Lindfield Learning Village Stage 2 and 3 - Car and Bus Access Option 4

Road Safety Audit

Concept Design Stage

JN20045_Report01 Rev02 - Savills LLV Bus Loop Option 4

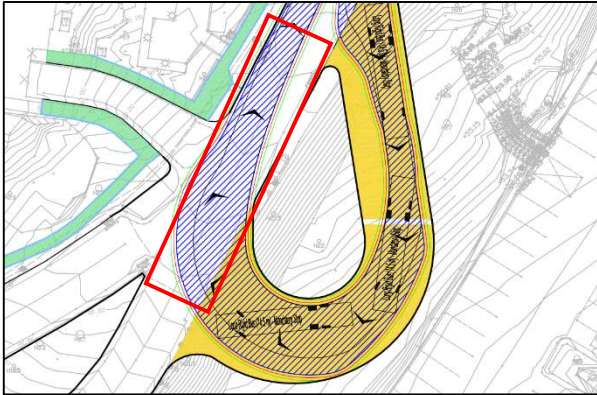
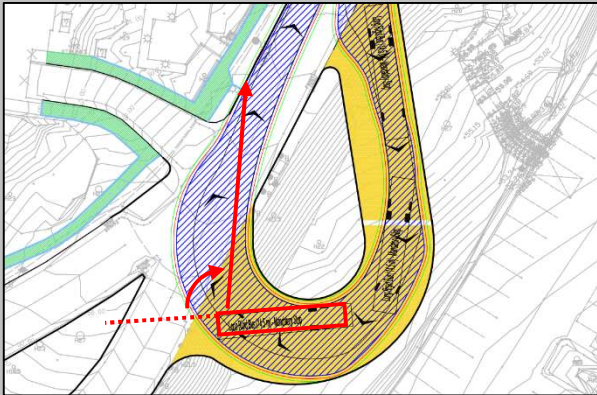
Item Location	Safety Hazard Finding	Frequency	Severity	Level Of Risk	Project Manager Response
1. Turn Paths Bus Stopping Area	<p>The turning path is shown to overhang approaching traffic.</p> <p>There is a risk that an exiting bus may impact oncoming traffic.</p> 	Probable	Minor	High	In the updated design, the roadway is 8m wide in this section which allows the bus to keep to their lane and reduce the risk of collision.

2. Access to Bus Bus Stopping Area	<p>The proposed bus stopping area is at road level.</p> <p>There is a significant height difference from the road level to the bus door.</p> <p>There is a risk that a passenger may trip/fall at significant height differences, in particular mobility impaired passengers.</p> 	Occasional	Limited	Low	Noted. Mobility impaired students are required to make special arrangements for direct access to the school as part of the Department of Education's policies and therefore are unlikely to be taking the bus.

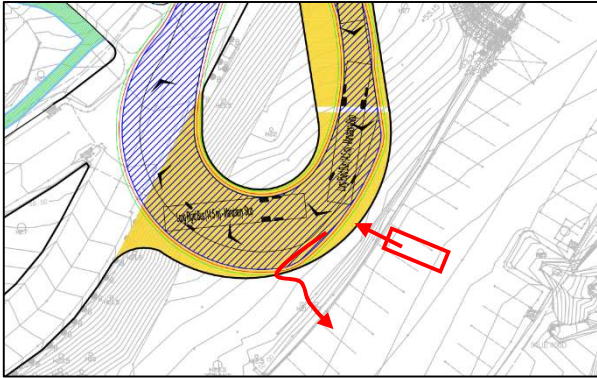
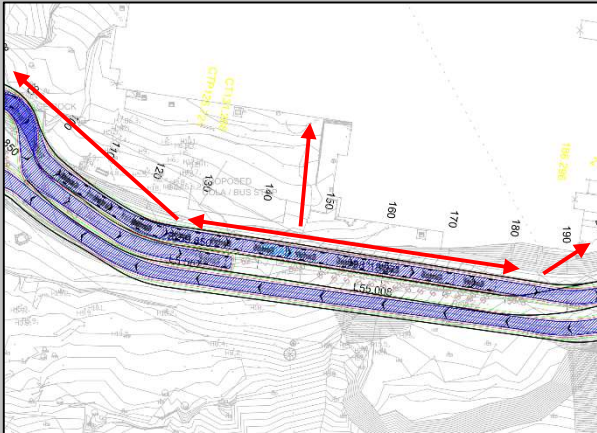
Item Location	Safety Hazard Finding	Frequency	Severity	Level Of Risk	Project Manager Response
3. Pedestrian Conflict Point Bus Stopping Area	<p>There is a pedestrian crossing at the point where bus stopping vehicles merge back in with through vehicles.</p> <p>There is a risk that a bus may block sight to a pedestrian using the pedestrian crossing resulting in pedestrian-vehicle collisions.</p> 	Occasional	Serious	High	Noted, this northern crossing would be removed in the updated design.

4. Merge-Diverge Bus Stopping Area	<p>It is unclear to the audit team to how vehicle diverge and merge is to be conveyed/managed for vehicles using the stopping area and for vehicles continuing through.</p> <p>There is a risk that a through vehicle may not anticipate a vehicle entering or exiting the stopping area resulting in sideswipe collisions.</p> 	Occasional	Limited	Low	The design of this area is proposed to match the design of on-road bus bays and therefore buses would have to merge back with through traffic. When buses are indicating, other vehicles must give way to them.

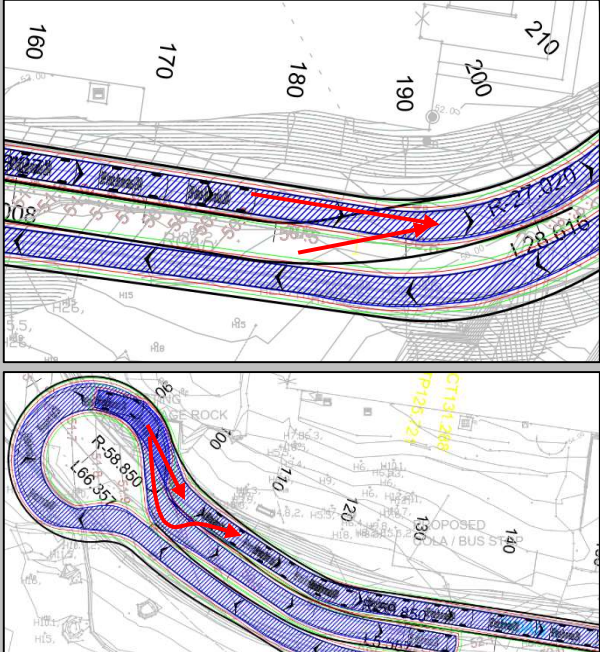
Item Location	Safety Hazard Finding	Frequency	Severity	Level Of Risk	Project Manager Response
5. Turning Area Turnaround Turning Path	<p>It is unclear to the audit team to what vehicles are allowed to use the turning area and how this information is to be conveyed.</p> <p>No further assessment has been carried out.</p> 	Note			<p>The turning area has been redesigned to send all vehicles through, as per a roundabout which should clear up potential confusion with the previous iteration of the design.</p>

6. Roundabout Turnaround Turning Path	<p>It is unclear to the audit team if the existing roundabout is to remain, if vehicles can turn at this point, if vehicles are required to turn at the turning head DOPU area, if vehicles may attempt to U-turn in the parking area.</p> <p>There is a risk that motorists may undertake unsafe turn around movements, such as U-turns, 3 point turns, mounting kerbs/footpaths etc. resulting in side swipe collisions, property damage to roadside objects or vehicle-pedestrian collisions.</p> 	Occasional	Serious	High	<p>The existing roundabout is to be expanded upon with the section of road to be one way north as part of the roundabout.</p>

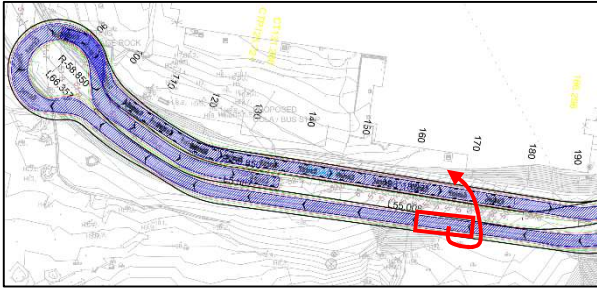
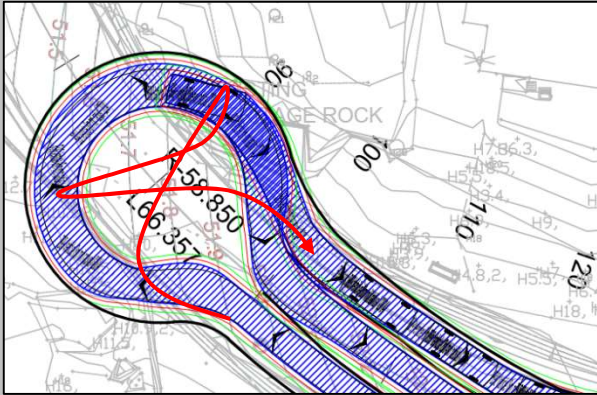
Item Location	Safety Hazard Finding	Frequency	Severity	Level Of Risk	Project Manager Response
7. Pedestrian Paths Turnaround Turning Path	<p>It is unclear to the audit team of the grades of proposed pedestrian paths, requirements for demolition of retaining structures, and vehicle priority or pedestrian crossings, required infrastructure such as steps or handrails, etc.</p> <p>No further assessment has been carried out.</p> 	Note			Noted, this is still being determined as the design is progressing.

Item Location	Safety Hazard Finding	Frequency	Severity	Level Of Risk	Project Manager Response
8. Bus Turn Path Turnaround Turning Path	<p>The bus turn path requires a significant amount of both travel lanes.</p> <p>There is a risk that through vehicles may block the turning path resulting in sideswipe collisions.</p> 	Probable	Minor	High	In the roundabout scenario, this area is one way which removes the conflict.
9. Bus Sightlines Turnaround Turning Path	<p>The position of the bus as it is about to turn into the through travel lane is angled.</p> <p>There is a risk that a driver may not have sufficient sight distances to approaching vehicles resulting in side impact collisions.</p> 	Occasional	Minor	Medium	In the roundabout scenario, this area is one way which removes the conflict.
